Access Compliance Report Public Rights-of-Way (Curb Ramps)

Intersection ID: 10025870Main Street:ELEVATION_POINT_DRCross Street: N/ALocation:SWADA ID: BAA621A21B79Ramp Type:PerpInitial Pass/Fail:FailOverall Compliance: NoSeverity Score:12.5

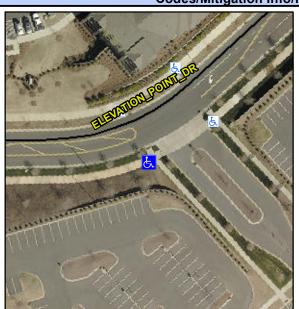
PROW/ADA:
R304.2.2

Comp	liance Description	Data	Comp	liance	Description	Data
N/A	Ramp Length (in)	92.0	No	Ramp	Slope (%)	8.5
Yes	Ramp Width (in)	59.0	Yes	Ramp	XSlope (%)	0.4
N/A	Flare Type LT	N/A	N/A	Flare	Type RT	N/A
N/A	Flare Slope LT (%)	N/A	N/A	Flare	Slope RT (%)	N/A
N/A	Flare Traversable LT?	N/A	N/A	Flare	Traversable RT?	N/A
N/A	Landing Length (in)	N/A	N/A	DWS	Provided?	N/A
N/A	Landing Width (in)	N/A	N/A	DWS	Contrast?	N/A
N/A	Landing Slope (%)	N/A	N/A	DWS	Length (in)	N/A
N/A	Landing X Slope (%)	N/A	N/A	DWS	Full Width?	N/A
N/A	Landing Curb? (Y/N)	N/A	N/A	DWS	Offset (in)	N/A
N/A	Shared Landing?	N/A				
N/A	Gutter Ponding?	N/A	N/A	Gutte	r Slope (%)	N/A
N/A	Gutter Lip Ht (in)	N/A	N/A	Gutte	r X Slope (%)	N/A
N/A	Painted X Walk1?	No	N/A	Painte	ed X Walk2?	N/A
	X Walk 1 Direction	To NW		X Wa	lk 2 Direction	N/A
N/A	X Walk 1 Width (in)	N/A	N/A	X Wa	lk 2 Width (in)	N/A
	X Walk 1 Slope (%)	0.4		X Wa	lk 2 Slope (%)	N/A
	X Walk 1 X Slope (%)	1.2		X Wa	lk 2 X Slope (%)	N/A

Possible Solutions:
Remove & Replace Entire Ramp.
